**Subject:** DA 0346/2019 - Attention Catriona Shirley - Submission of Objection

# **PLANNING PARTNERSHIPS Pty Ltd**

**RE: DA 0346/2019 – 37 Grandview Pde, Mona Vale – alterations and additions to dwelling**

**Image 1** - Existing view of Mona Vale Beach and surf break from ground floor living room and balcony of No. 46 Grandview Pde. Note view corridor of beach between 37 & 39 Grandview Pde

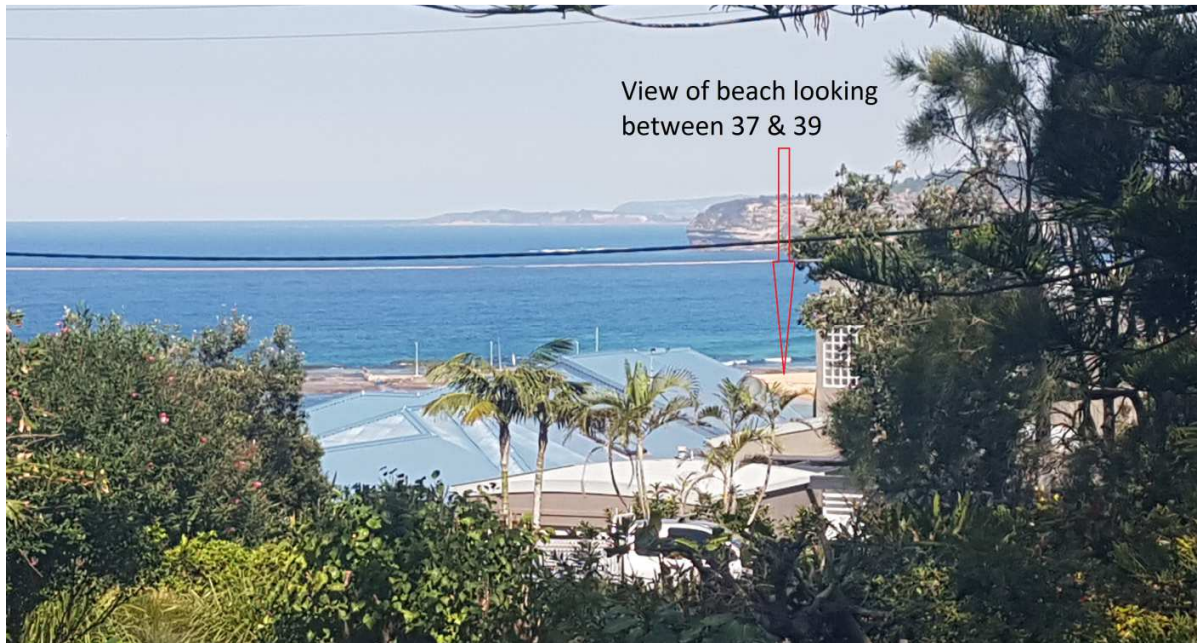
**Description of existing view** – From No.46 Grandview Parade, local views of the beach and surf break are obtained from the front living room and deck, looking in a southerly direction past and over the north-eastern corner of the existing dwelling at No.37, and over the roof of No.39. Being a local view that is 'dynamic' involving water movement on the shore, waves breaking and surfers riding waves, this is the key element of view interest to No.46. This is demonstrated in **Image 1** over page. Distant static views of Turimetta Head to the south are also noted.

It is understood that the existing dwelling at No.37 Grandview Pde was specifically designed circa 2003 (through negotiation with Council and neighbours), stepping the first storey back from the ground floor in order to satisfy the view sharing controls of the DCP.

**Image 2** - Indicative outline of proposed additions at front of 37 Grandview Pde, demonstrating complete loss of view of the beach and surf break from 46 Grandview Pde

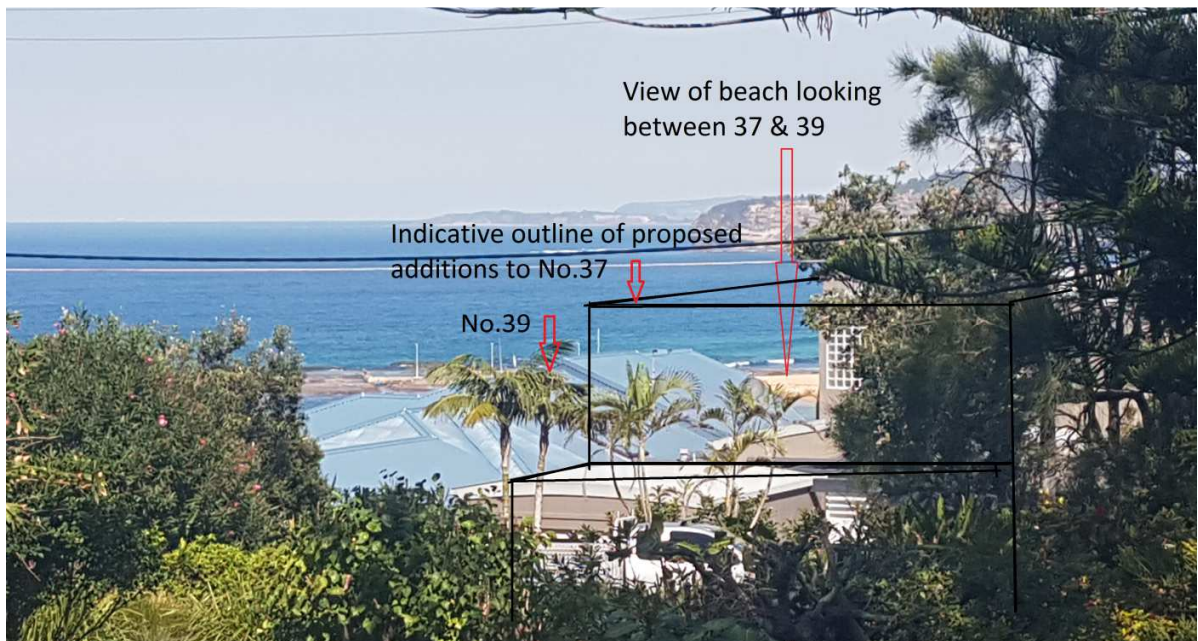
**View impact** - The proposed additions extend the first storey forward / north to the rear of the existing garage while retaining the existing eave height of the existing first storey. This has the effect of blocking the existing view corridor to the beach and surf break from No.46. Refer to **Image 2** below depicting this impact. Clearly this demonstrates that the proposal does not comply with the DCP's view sharing control.
